Access Compliance Report

Public Rights-of-Way

(Curb Ramps)

Intersection ID: 44482	Main Street: AINSWORTH_ST	Cross Street: REDDING_GLEN_AV	Location: SE
ADA ID: 55E6DD3ED3EC	Ramp Type: BlendTrans1	Initial Pass/Fail: Fail	Overall Compliance: No
		Severity Score: 10

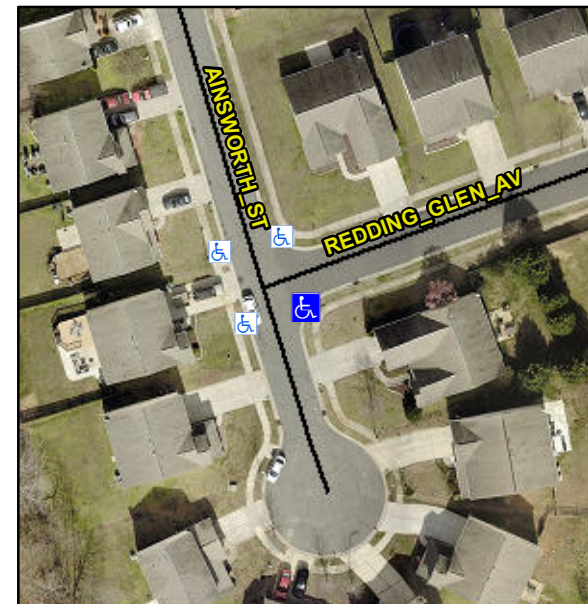
Not Found, R304.5.1, R304.5.3

Compliance	Description	Data	Compliance	Description	Data
N/A	Ramp Length (in)	46.5	Yes	BlendTrans Slope (%)	3.8
No	Ramp Width (in)	47.0	No	BlendTrans XSlope (%)	3.9
N/A	Flare Type LT	N/A	N/A	Flare Type RT	N/A
N/A	Flare Slope LT (%)	N/A	N/A	Flare Slope RT (%)	N/A
N/A	Flare Traversable LT?	N/A	N/A	Flare Traversable RT?	N/A
N/A	Landing Length (in)	N/A	N/A	DWS Provided?	N/A
N/A	Landing Width (in)	N/A	N/A	DWS Contrast?	N/A
N/A	Landing Slope (%)	N/A	N/A	DWS Length (in)	N/A
N/A	Landing X Slope (%)	N/A	N/A	DWS Full Width?	N/A
N/A	Landing Curb? (Y/N)	N/A	N/A	DWS Offset (in)	N/A
N/A	Shared Landing?	N/A			
N/A	Gutter Ponding?	N/A	N/A	Gutter Slope (%)	N/A
N/A	Gutter Lip Ht (in)	N/A	N/A	Gutter X Slope (%)	N/A
N/A	Painted X Walk1?	No	N/A	Painted X Walk2?	No
	X Walk 1 Direction	To N		X Walk 2 Direction	To W
	X Walk 1 Width (in)	N/A		X Walk 2 Width (in)	N/A
	X Walk 1 Slope (%)	4.2		X Walk 2 Slope (%)	2.8
	X Walk 1 X Slope (%)	0.3		X Walk 2 X Slope (%)	3.3

N/A	Ramp inside XWalk1?	N/A	N/A	Ramp inside XWalk2?	N/A
	Road Slope (%)	3.3		Clear Space?	N/A
	Road X Slope (%)	5.5	N/A	Clear Space to XWalk (in)	N/A
N/A	Any Obstructions?	N/A	N/A	Storm Grate/Utility Hazard?	N/A
	Obstruction Type			Storm Grate/Utility Type	
		N/A			N/A
			Yes	Surface Condition? (G/P)	Good
			No	Curb Slope (%)	13.1

Remove & Replace Curb Ramp With Two New Directional Ramps or Equivalent.
